**TO:** Dr. Jesse Bacon, Superintendent  
**FROM:** Danny Clemens, Director of Facilities  
**Date:** January 21, 2024  
**RE:** Bernheim Change Order 33 - Added Coiling Door at Concessions **DC**

## Change Order

**PROJECT:** *(Name and address)*  
Bernheim Middle School Renovation  
700 Audubon Drive, Shepherdsville, KY  
40165

# Change Order Request 52 - PCO #156 - Add Coiling Door at Concession Stand

Description: 640, 6' 0" x 4' 4 1/4" Opening

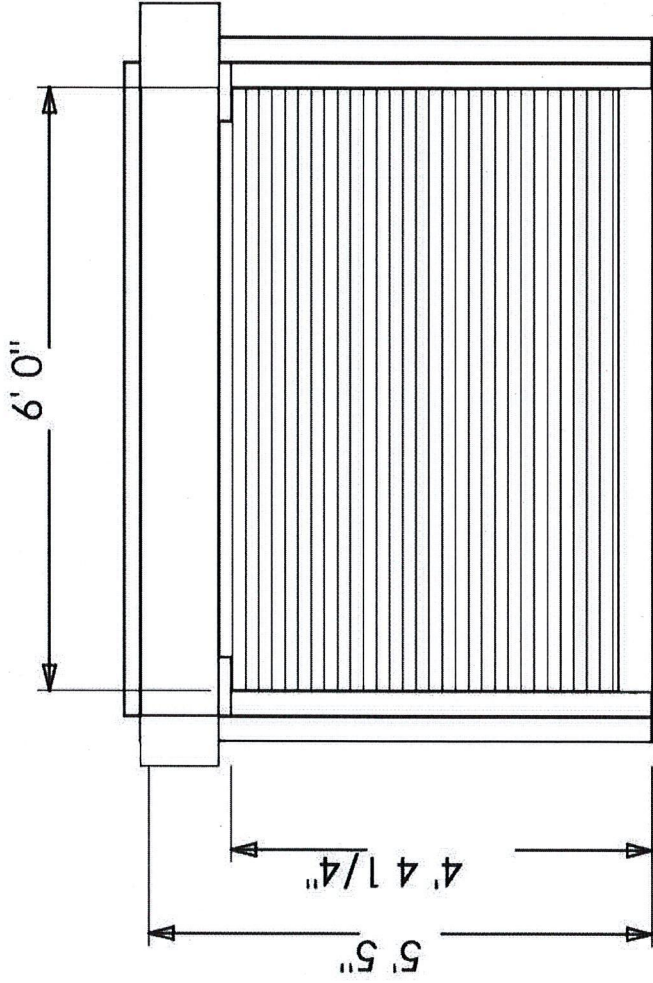
Add Coiling Door at Concession Stand

Item	Qty
1 640.RD 640, 6' 0" x 4' 4 1/4" Opening	1
Mounting: R: Masonry-Solid Block, Face Mount; L: Masonry-Solid Block, Face Mount; Lintel - Masonry-Solid Block, Header - Masonry-Solid Block	
Curtain: 3 Hour UL/ULC, F158, Steel, Primed Gray, 22 gauge, Interior Mtd Above Lintel, Alternate Endlock	
Tension Release: Tension Release	
Operation: Push Up w/Governor, Right Hand	
Bottom Bar: Single Angle -Shutter, Steel, Powder Coat-Black, Astragal, Slide Lock, Both Jambs, Coil Side	
Wall Thickness: 8" Wall	
Guide: Steel, Powder Coat-Black, Brush-1 Side, Double Flared Entry	
Hood: Square, Steel, Gray, Primed, Exterior Weather Baffle, Omit Hood Label, Drive and Tension (Non-Drive)	
Bracket: Steel, Powder Coat-Black	
Misc: Unitized, Steel, Powder Coat-Black, Brush-1 Side, Double Flared Entry	
Last Changed: 12/16/2024 10:53 AM EST
